Access Compliance Report Public Rights-of-Way (Curb Ramps)

Main Street: AIROSO_ST Cross Street: CIMA_DR Location: SE

ADA ID: RPRK211119150459 Ramp Type: Type 1 - Perpendicular Diagonal Initial Pass/Fail: Fail Overall Compliance: No Severity Score: 16

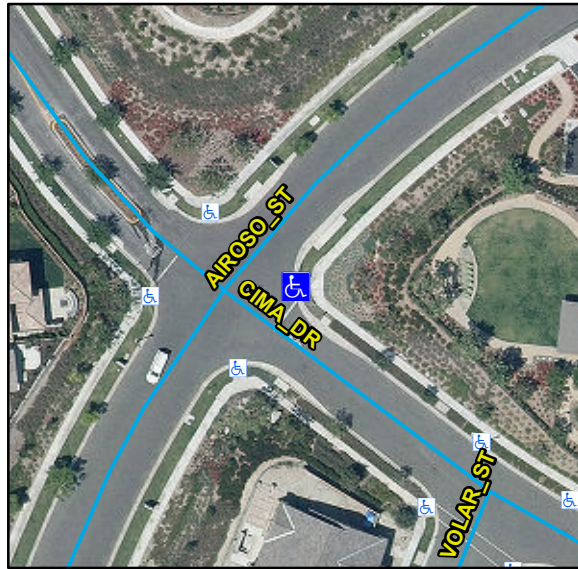
Compliance	Description	Data	Compliance	Description	Data
N/A	Ramp Length (in)	78	N/A	Flare Type LT	
Yes	Ramp Width (in)	63			N/A
No	Ramp Run Slope (%)	8.4	N/A	Flare Slope LT (%)	N/A
No	Ramp Cross Slope (%)	2.9	N/A	Flare Traversable LT	N/A
N/A	Landing Present	N/A	N/A	Flare Type RT	
N/A	Landing Length (in)	N/A			N/A
N/A	Landing Width (in)	N/A	N/A	Flare Slope RT (%)	N/A
N/A	Landing Run Slope (%)	N/A	N/A	Flare Traversable RT	N/A
N/A	Landing Cross Slope (%)	N/A	N/A	DWS Provided	N/A
N/A	Landing Movement Obstructed?	N/A	N/A	DWS Contrast	N/A
	Landing Movement Type	N/A	N/A	DWS Length (in)	N/A
N/A	Landing Shared	N/A	N/A	DWS Full Width	N/A
N/A	Clear Space	Yes	N/A	DWS Offset Left (in)	N/A
N/A	Clear Space To Crosswalk (in)	N/A	N/A	DWS Offset Right (in)	N/A
N/A	Marked Crosswalk 1	No	N/A	Marked Crosswalk 2	No
	Crossing 1 Direction	N		Crossing 2 Direction	W
	Marked Crosswalk 1 Width (in)	N/A		Marked Crosswalk 2 Width (in)	N/A

N/A	Ramp Inside Crosswalk 1	N/A	Yes	Ramp Inside Crosswalk 2	N/A
	Crossing 1 Slope (%)	2.3		Crossing 2 Slope (%)	1.3
	Crossing 1 Cross Slope (%)	4.7		Crossing 2 Cross Slope (%)	2.1
N/A	Gutter Ponding	N/A	No	Curb Slope	11.8
Yes	Gutter Lip Height (in)	0		Road Run Slope (%)	3.8
N/A	Gutter Run Slope (%)	N/A		Road Cross Slope (%)	0.2
N/A	Gutter Cross Slope (%)	N/A			
Yes	Overall Surface Condition: Acceptable		Yes	Perp Joint Present	Yes
	Cross Gutter Present?	No		Spandrel Present?	No
	Replace Cross Gutter?	N/A		Replace Spandrel?	N/A

Remove & Replace Curb Ramp With Two New Directional Ramps or Equivalent.

R304.2.2, R304.5.3, STD 1115
